**Environmental Impact Assessment (EIA) Ordinance, Cap. 499
Application for Variation of an Environmental Permit**

**Project Title: South East New Territories (SENT) Landfill Extension
(Application No. VEP-521/2016)**

Pursuant to Section 13(5) of the EIA Ordinance, we have amended the Environmental Permit (EP-308/2008/A). I attach the Environmental Permit as amended (No. EP-308/2008/B) for your use.

VEP-521/2016	29 December 2016 2016年12月29日	<p>(1) Amend conditions 2.8, 2.10 and 2.13 and figures 2 & 3 in Part C of Environmental Permit No. EP-308/2008/A</p> <p>更改環境許可證編號EP-308/2008/A的C部的第2.8、2.10及2.13項條件和圖2及圖3</p>	20 January 2017 2017年1月20日

Figure 2: Landscape and Visual Mitigation Measures

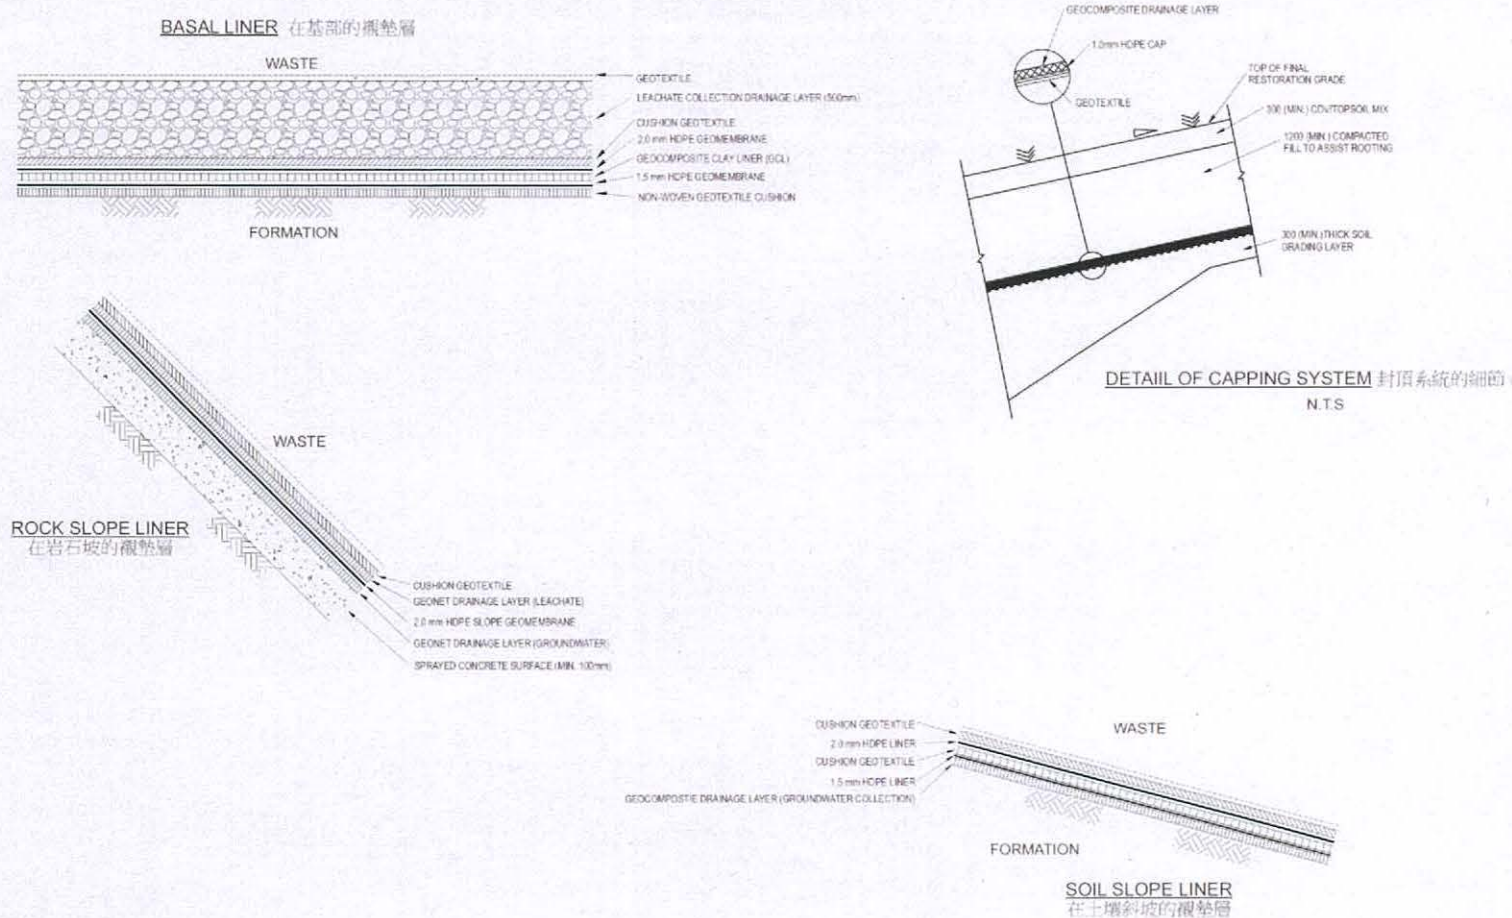
- 2.8 The permit Holder shall, within 3 months of possession of the Project site, plant advance screen planting of native species at Light Standard size at 1.5 m centres apart along the High Junk Peak Trail as indicated in Figure 2 or on area agreed by the Director, so as to screen views of the Project from the trail, unless otherwise agreed by the Director. Planting shall be completed within 9 months of taking possession of the Project site.

許可證持有人在接管工程項目工地起計三個月內，須按圖 2 所示沿釣魚翁郊遊徑路旁或署長同意的範圍，以每隔 1.5 米的株距，預先栽種標準大小的本地品種植物作為屏障，以遮擋從郊遊徑望向工程項目方向的景觀，除非另獲署長同意。種植工程須在接管工程項目工地起計九個月內完成。
